Access Compliance Report

Public Rights-of-Way

(Curb Ramps)

Intersection ID: 18995	Main Street: SEACROFT_RD	Cross Street: TYVOLA_RD	Location: SE
ADA ID: EAF31D8E0936	Ramp Type: PerpDiag	Initial Pass/Fail: Fail	Overall Compliance: No
Codes/Mitigation Info/Possible Solution		Field Measurements/Component Compliance	
Severity Score: 21.25

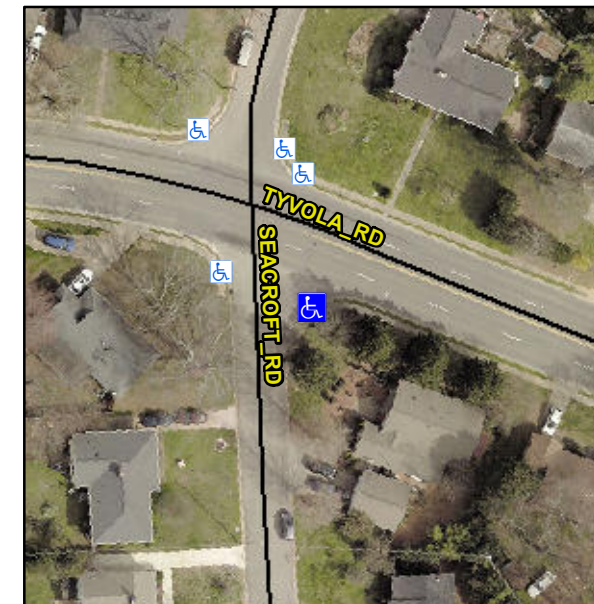
Not Found, R304.5.1, R304.5.3

Compliance	Description	Data	Compliance	Description	Data
N/A	Ramp Length (in)	60.0	Yes	Ramp Slope (%)	8.0
No	Ramp Width (in)	36.0	No	Ramp XSlope (%)	6.3
N/A	Flare Type LT	N/A	N/A	Flare Type RT	N/A
N/A	Flare Slope LT (%)	N/A	N/A	Flare Slope RT (%)	N/A
N/A	Flare Traversable LT?	N/A	N/A	Flare Traversable RT?	N/A
N/A	Landing Length (in)	N/A	N/A	DWS Provided?	N/A
N/A	Landing Width (in)	N/A	N/A	DWS Contrast?	N/A
N/A	Landing Slope (%)	N/A	N/A	DWS Length (in)	N/A
N/A	Landing X Slope (%)	N/A	N/A	DWS Full Width?	N/A
N/A	Landing Curb? (Y/N)	N/A	N/A	DWS Offset (in)	N/A
N/A	Shared Landing?	N/A			
N/A	Gutter Ponding?	N/A	N/A	Gutter Slope (%)	N/A
N/A	Gutter Lip Ht (in)	N/A	N/A	Gutter X Slope (%)	N/A
N/A	Painted X Walk1?	No	N/A	Painted X Walk2?	No
	X Walk 1 Direction	To N		X Walk 2 Direction	To NW
N/A	X Walk 1 Width (in)	N/A	N/A	X Walk 2 Width (in)	N/A
	X Walk 1 Slope (%)	2.2		X Walk 2 Slope (%)	7.1
	X Walk 1 X Slope (%)	7.0		X Walk 2 X Slope (%)	0.5

Remove & Replace Curb Ramp With Two New Directional Ramps or Equivalent.
